Addendum No. 1 **February 6, 2025**

#### City Project No. 23-067 Package 1 **Roads Program Capital Improvement Project**

**SS-6**

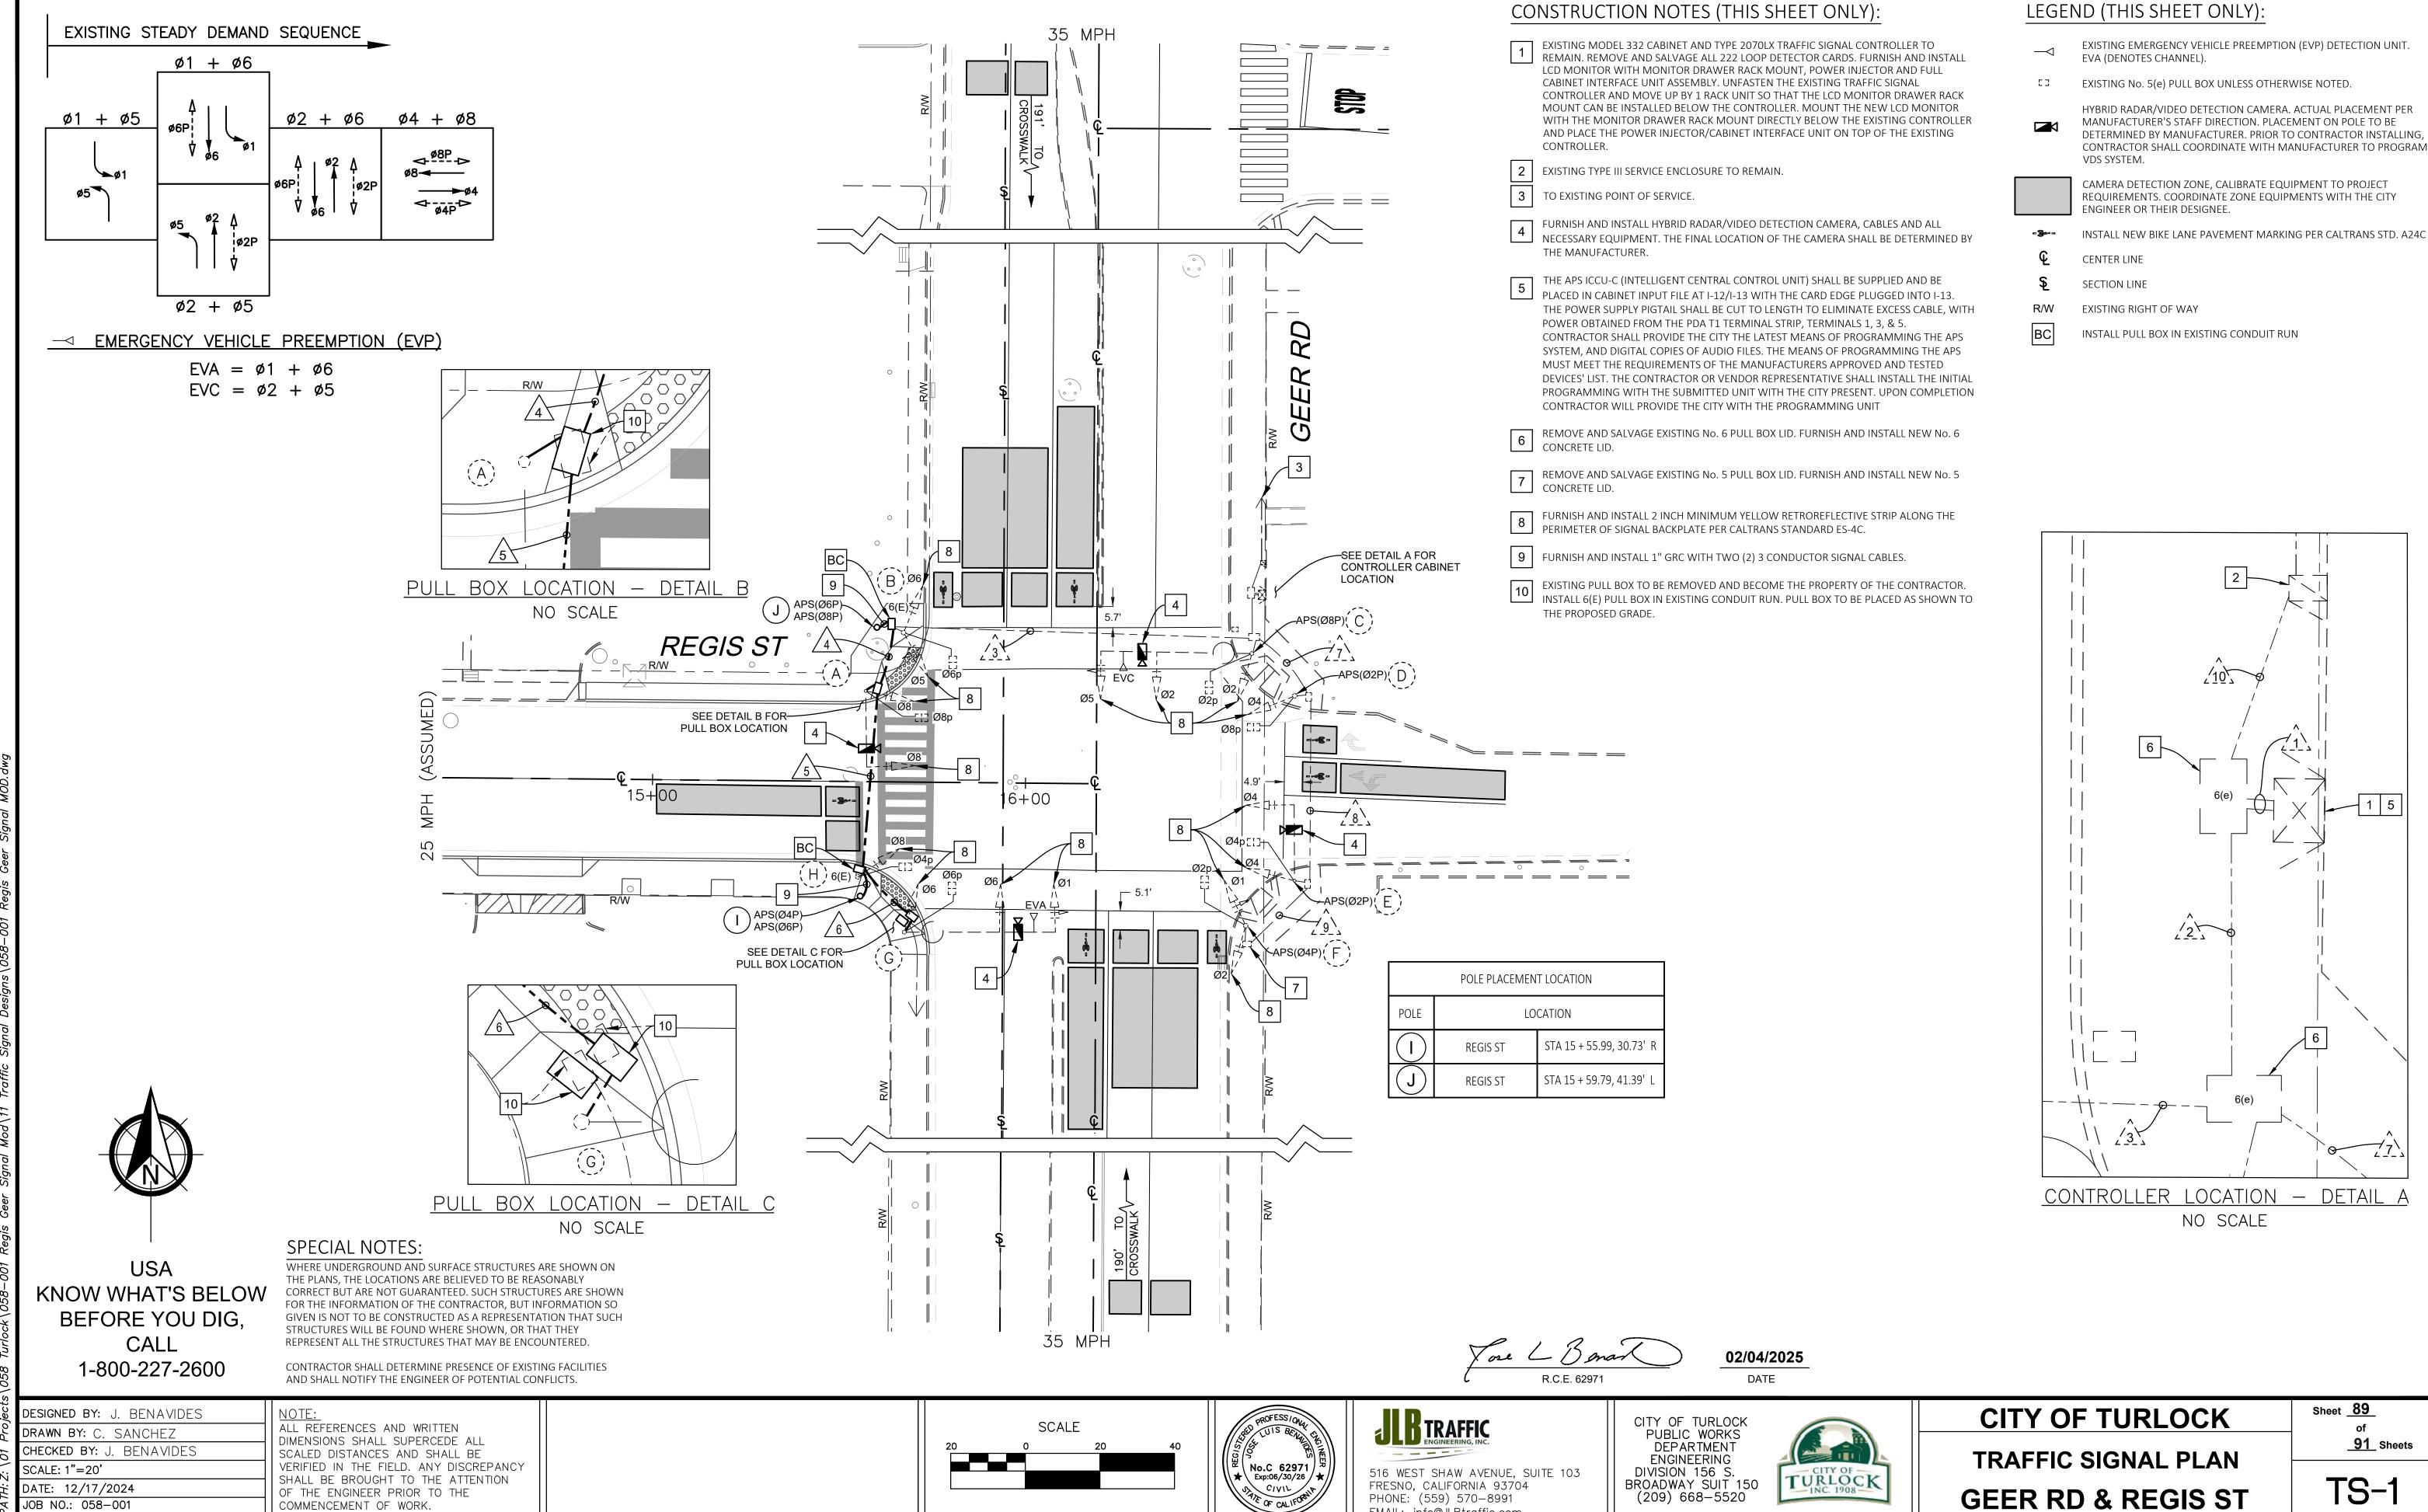
Delete sheets SS-1, SS-2, SS-5 and SS-6 and replace with attached sheets SS-1, SS-2, SS-5 and SS-6 of this addendum. Revisions consist of adding Sharrows along the following streets: Regis Street, Niagra Street from Regis Street to Tampa Street, Tampa Street, Andre Lane from Tampa Street to Georgetown Ave.
